# LIFE 18™ apheresis unit Field safety notice

Surveillance gap in the blood leak detection of the LIFE 18™ apheresis system

Figure: connection of Disk Separator with Theraline or TPE Line pump cassette.

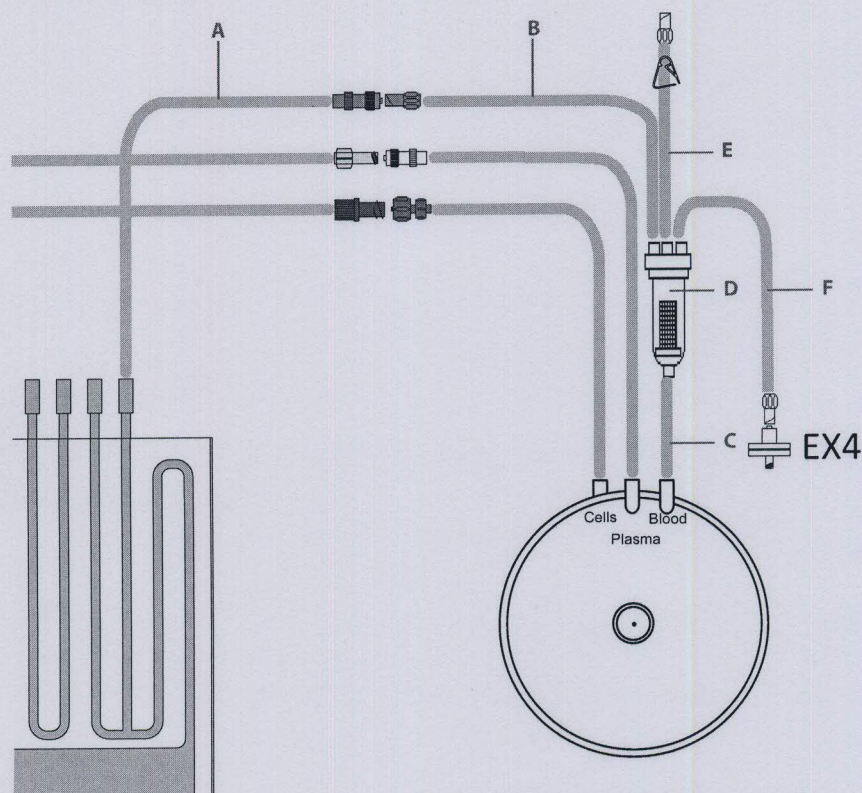
During a treatment blood is withdrawn from the venous access of the patient and delivered to the Disk Separator via the tubing lines (depicted as A to C in the figure above) and the Disk Separator drip chamber (depicted as D). The pressure in the drip chamber is monitored by external sensor EX4. This flow path is checked for tightness during the set-up procedure.

If a leak develops in this flow path of the blood during the treatment, usually the pressure will drop and the external pressure sensor EX4 will raise an alarm if the pressure is not fluctuating (or alternating) within a certain range.

Tests in our laboratory have shown the possibility that under certain circumstances the LIFE 18 apheresis unit will not interrupt the treatment and stop all pumps if a blood leak occurs in the tubing of the Disk Separator (anywhere between A and F in the figure above).

If such a phenomenon occurs during treatment and would remain undetected by the user, the patient might lose significant blood volumes.

**Please make sure that the patient connected with the LIFE 18 apheresis unit never remains unattended during the treatment. Please check for tubing set integrity regularly during the treatment.**

Our company is working hard to solve this potential problem by a modified software with an improved surveillance of the blood pumps. The development, verification, validation and release of the revised software however will probably require several weeks. In addition, the thorough installation of the revised software on all LIFE 18 apheresis units by our qualified service engineers will also require significant time.
